Project	<b>IEEE 802.16 Broadband Wireless Access Working Group</b> < <a href="http://ieee802.org/16">http://ieee802.org/16</a> >	
Title	<b>Updating figure for Master Priority Order</b>	
Date Submitted	<b>2007-11-04</b>	
Source(s)	Wu Xuyong Huawei, Huawei Industry Base, Bantian, Longgang, Shenzhen, China 518129	Voice: +86-755-28976776 Fax: <a href="mailto:wuxuyong@huawei.com">wuxuyong@huawei.com</a> ,
Re:	<b>IEEE 802.16-07/050: IEEE 802.16 Working Group Letter Ballot #29: Announcement (2007-10-05)</b>	
Abstract	<b>Updating figure for Master Priority Order</b>	
Purpose	To consolidate the 16h draft.	
Notice	This document has been prepared to assist IEEE 802.16. It is offered as a basis for discussion and is not binding on the contributing individual(s) or organization(s). The material in this document is subject to change in form and content after further study. The contributor(s) reserve(s) the right to add, amend or withdraw material contained herein.

## Updating figure for Master Priority Order

Figure h52 —Priority Order for a 3 system community

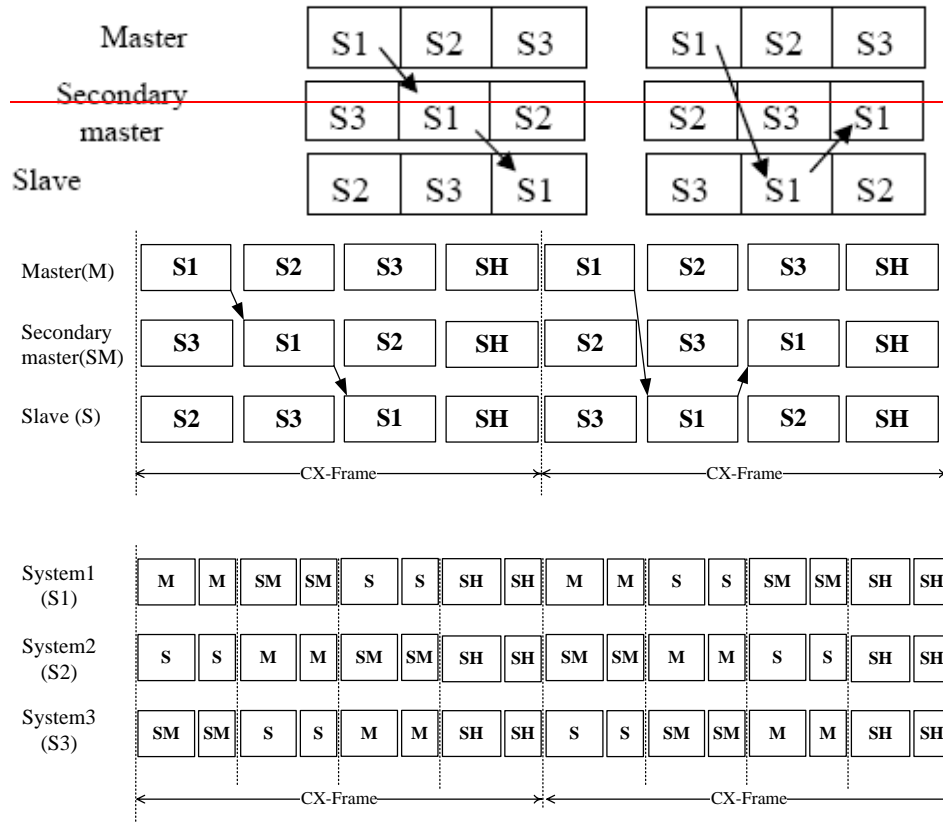
*The following figure in illustration of Master Priority Order should be update accordingly to show it in CX-Frame structure.*

Figure h52 shows the priority order for 3 systems in different sub-frame structures. The common parts and TX/RX boundaries are omitted. The arrows show the priority demotion and promotion for system S1.

In order to enable service to regions in which two slave systems overlap, a hierarchy structure shall be applied among the slaves, as follows:

Let S1 denote the master system of the first frame (CX\_MAC\_NO=1), S2 the master system the second frame (CX\_MAC\_NO=2) and S3, the master system of the third frame (CX\_MAC\_NO = 3). In the first set of 3 frames the systems priority will be demoted from frame to frame:

In case the MAC frame number (CX\_MAC\_NO) is on above a multiple of 6 ( $CX\_MAC\_NO \bmod 6=1$ ), S3 will be the secondary master in the frame

In case  $CX\_MAC\_NO \bmod 6 =2$ , S1 will be the secondary master

In case  $CX\_MAC\_NO \bmod 6 =3$ , S2 will be the secondary master

In the second set of 3 frames the systems priority will be demoted from frame to frame

In case  $CX\_MAC\_NO \bmod 6 =4$ , S2 will be the secondary master

In case  $CX\_MAC\_NO \bmod 6 =5$ , S3 will be the secondary master

In case  $CX\_MAC\_NO \bmod 6 =0$ , S1 will be the secondary master of sub-frame 3.

When system Si has priority over system Sj, it means that system Sj will not transmit a signal that would interfere with any SS of system Si.
